## RFQ 2FY20 Vendor Question 25

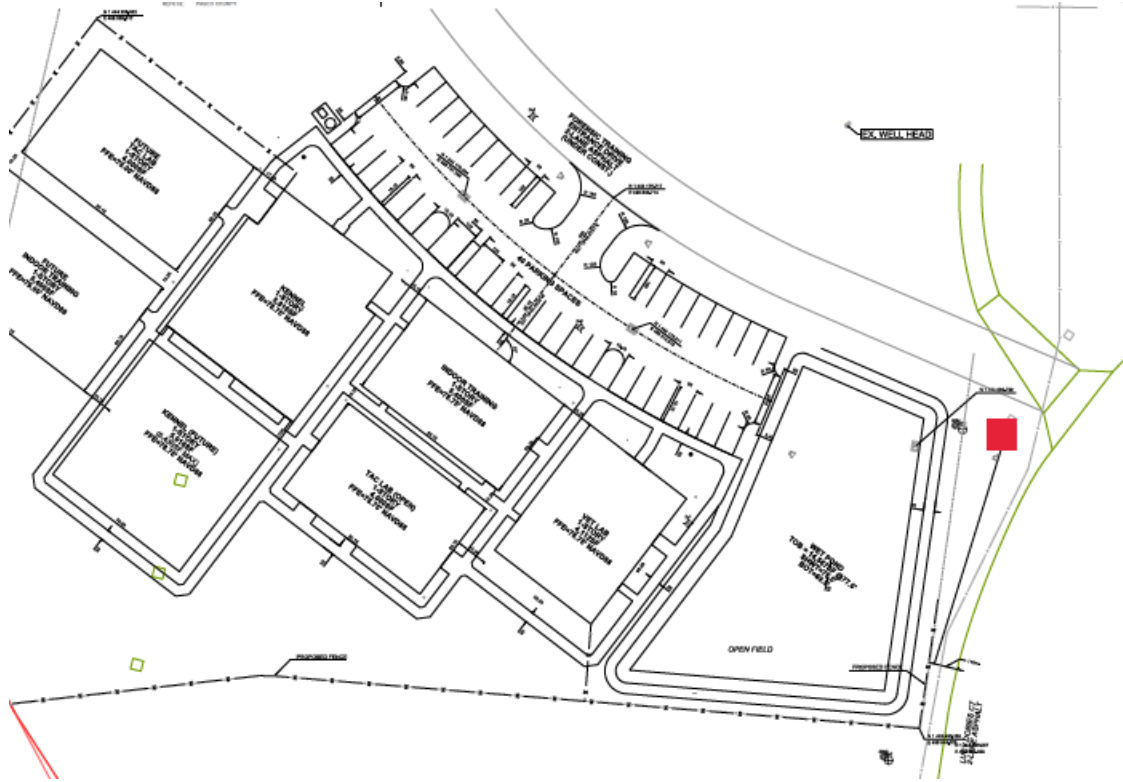
1. In reference to the electrical power to the buildings, an electrical site plan was not issued with the bid documents. Please advise the location of the electrical transformer the utility company will be providing. Unless directed otherwise, one transformer will be anticipated for all three buildings 100' away for the secondary conduit run and 100' for the primary conduit run. **The electrical transformer is already in place at the intersection of Lucy Dobies Court and Charles Bo Harrison Way. It is in the northeast corner of the K9 site. Approximate location indicated in image below.**
